**DEFENSE NUCLEAR FACILITIES  
SAFETY BOARD**

October 14, 2020

## Staff Report

### General Corrosion Allowance for 304L and 316L Stainless Steel in the Waste Treatment and Immobilization Plant

**Figure 1.** Arrhenius plot of corrosion rates for stainless steel in 50 wt% NaOH solutions.

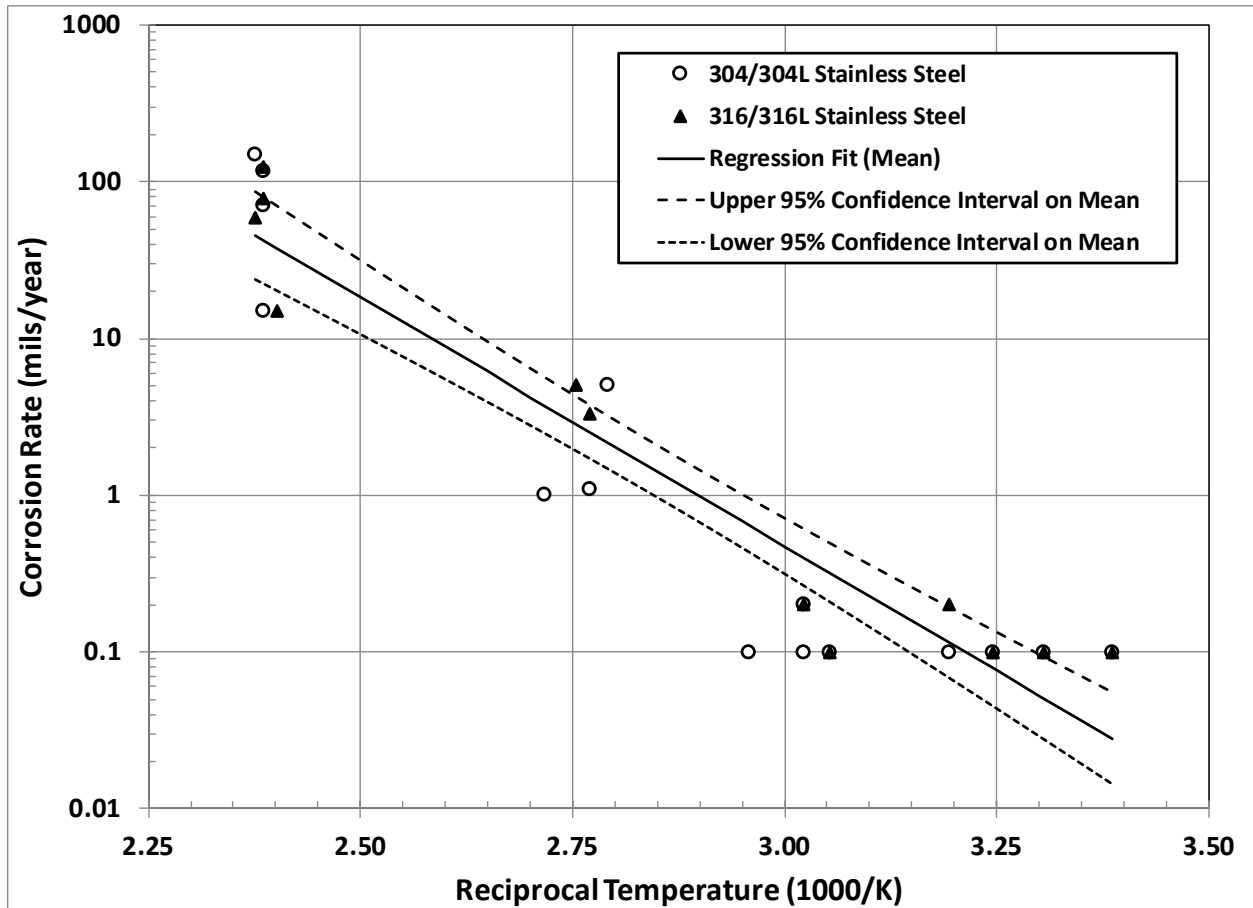
*Determining Corrosion Rate as a Function of Temperature*—Corrosion of stainless steel is a thermally activated process and therefore an Arrhenius equation is generally used to predict the exponential effect of temperature on corrosion rate [1]. Figure 1 below shows the general corrosion rate data from Table 1 plotted on a logarithmic scale as a function of reciprocal temperature. The solid line is a regression fit to an Arrhenius equation of the combined 304/304L and 316/316L stainless steel data:

where CR is corrosion rate, A is a normalized constant corrosion rate,  $E_a$  is the activation energy for corrosion, R is the gas constant, and T is absolute temperature. The correlation coefficient,  $r = 0.943$  ( $r^2 = 0.888$ ), implies a linear relationship between  $\log(CR)$  and  $1/T$  and supports the premise that the rate-controlling mechanism for corrosion remains constant over the temperature range of Figure 1.

*Determining Activation Energy for Corrosion*—The slope of the solid line in Figure 1 represents the activation energy for corrosion (divided by the gas constant, R), which can be compared with results reported in the literature. The activation energy in Figure 1 is 61 kilojoules (kJ)/mol, a relatively high value that reflects the large increase in measured corrosion rates for data tested at temperatures above approximately 185°F (less than 1000/Kelvin (K) = 2.79 in Figure 1). The standard deviation of the activation energy is 4.3 kJ/mol and the 95 percent confidence interval on the activation energy is  $61 \pm 8.9$  kJ/mol, which corresponds to a 95 percent confidence that the activation energy range is between 52–70 kJ/mol. Reference 7 lists 316L stainless steel corrosion rate data reported in Reference 8 from tests in 0.1 M (0.4 wt%) NaOH concentrated alkaline (pH = 13) solutions at three different temperatures. A survey of corrosion data reported in Reference 9 shows an Arrhenius plot of the three 0.4 wt% NaOH solution data points tested at temperatures of 86–176°F as reported in References 7 and 8. The corrosion rates were very low (< 0.01 mpy), as would be expected for such a low NaOH concentrated alkaline solution at these temperatures. The activation energy for corrosion of 316L stainless steel calculated from this data is 50 kJ/mol [9].

**Figure 2a.** Corrosion rates for stainless steel in 50 wt% NaOH solutions up to the boiling point.

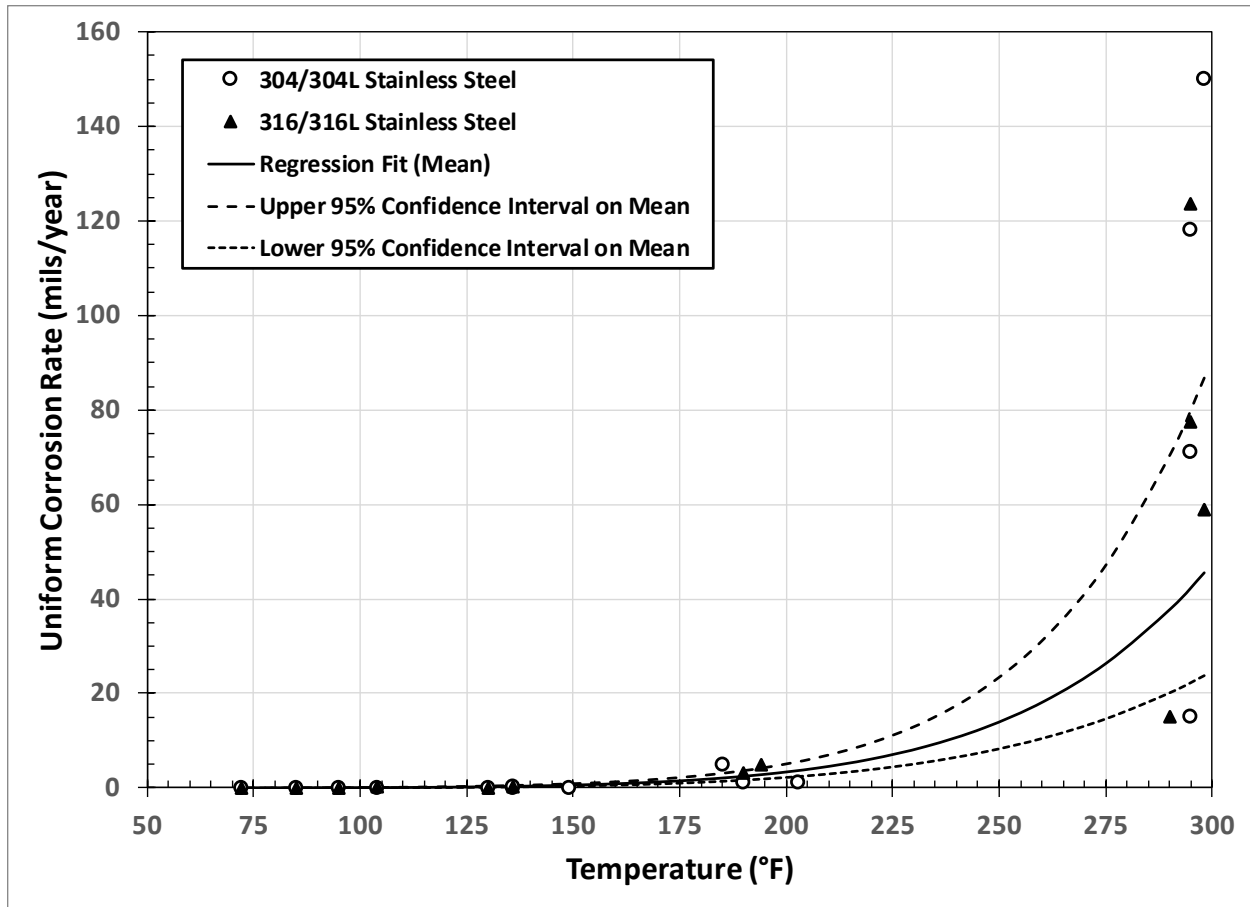
*Plotting Mean Corrosion Rate as a Function of Temperature*—Figures 2a and 2b below show the corrosion rate data from Figure 1 plotted as a linear function of temperature. Figure 2a shows all data at temperatures up to the boiling point of 50 wt% NaOH solution (~295°F), while Figure 2b shows the corrosion rate data only in the range of WTP allowable operating temperatures (< 200°F) for 316L stainless steel. The solid line in Figures 2a and 2b is the regression fit to the Arrhenius equation from Figure 1, which shows how the mean (expected) corrosion rate increases with temperature. The dashed lines show the upper and lower 95 percent confidence interval representing the highest and lowest mean values of corrosion rate at each value of temperature.

There is a relatively large amount of scatter in the corrosion rate data of Figure 2a measured at the boiling point and a relatively large variation of 1–5 mpy in the corrosion rate data of Figure 2b measured at 185–194°F. This is typical of the natural variability in experimental data that increases exponentially with temperature. The scatter is shown to be more uniform over the entire temperature range when the data is presented on a semi-log scale in an Arrhenius plot as shown in Figure 1 above. Because the regression fit is derived by minimizing the sum of the squares of the errors or scatter in the data, the solid line is the statistical best fit to the data. Approximately half of the data points lie above the regression fit (solid line) and approximately half lie below the solid line in Figures 1 and 2. The dotted line in Figure 2b shows WTP project's general corrosion allowance of 0.6 mpy.

**Figure 2b.** Corrosion rates for stainless steel in 50 wt% NaOH solutions at WTP operating temperatures.

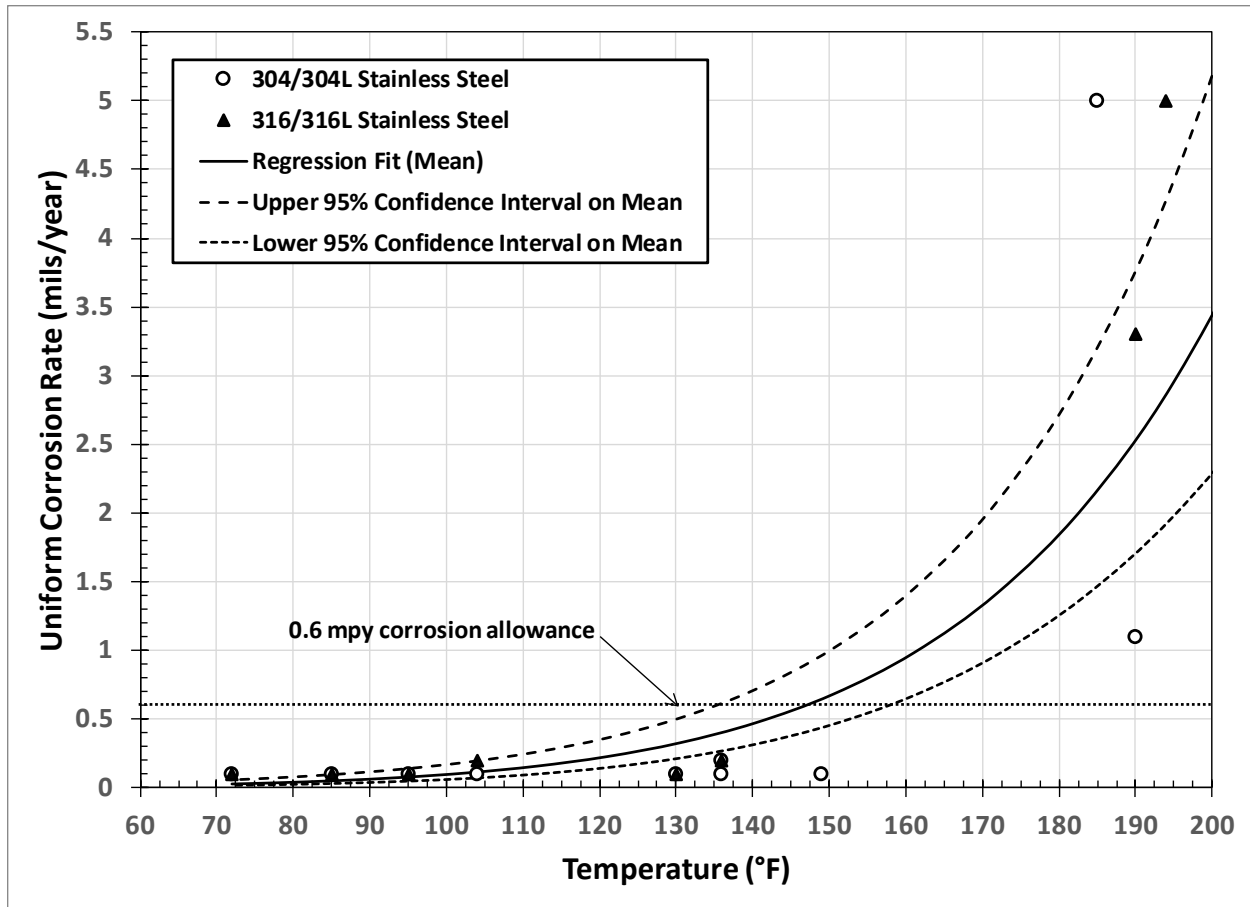
Figure 2b shows that all four of the corrosion rate data points from 185–194°F exceed WTP project’s general corrosion allowance of 0.6 mpy. Although the sole data point (149°F) from 137–184°F is well below the regression fit solid line, this data point is inconsistent with the corrosion rate data from 130–136°F and is essentially the same rate measured at 72–95°F. The corrosion rate is expected to increase exponentially with temperature as most of the other data in Figure 2 shows. The regression fit (solid line) in Figure 2b predicts the mean corrosion rate exceeds WTP project’s general corrosion allowance of 0.6 mpy (dotted line) at temperatures above ~147°F. The mean corrosion rate is predicted to be ~3 mpy in a 50 wt% NaOH solution at 194°F based on a regression fit to an Arrhenius equation of all the data measured from 72–298°F. The lower 95 percent confidence interval (short dashed line) in Figure 2b predicts with 95 percent confidence that the mean corrosion rate exceeds 0.6 mpy at temperatures above ~158°F. This is significant because the solid line is the predicted mean corrosion rate for 304L/316L stainless steel whereas the dotted line is WTP project’s bounding corrosion rate of 0.6 mpy for 304L stainless steel at temperatures up to 150°F and for 316L stainless steel at temperatures up to 200°F. The mean corrosion rate is predicted with 95 percent confidence to be at least ~2 mpy in a 50 wt% NaOH solution at 194°F based on a regression fit to an Arrhenius equation of all the data measured from 72–298°F.

This increase in stainless steel corrosion rate with increasing NaOH concentration is consistent with 304 stainless steel potentiodynamic anodic polarization data from the literature showing increasing current density and shifting of corrosion potential in the active direction with increasing NaOH concentration from  $10^{-3}$  M (0.004 wt%) to 2.5 M (10 wt%) [11]. The regression fit of all the data measured from 72–298°F in 50 wt% NaOH solutions shown in Figures 1 and 2 predicts a mean general corrosion rate of 2.5 mpy with a lower 95 percent confidence interval of 1.7 mpy for 304/304L or 316/316L stainless steel at 190°F. This is well above the WTP project’s general corrosion allowance of 0.6 mpy. The four general corrosion rate data points at 185–194°F in 50 wt% NaOH solutions vary from 1–5 mpy in Figure 2b,

consistent with the regression fit prediction of the mean general corrosion rate of 2.5 mpy at 190°F.
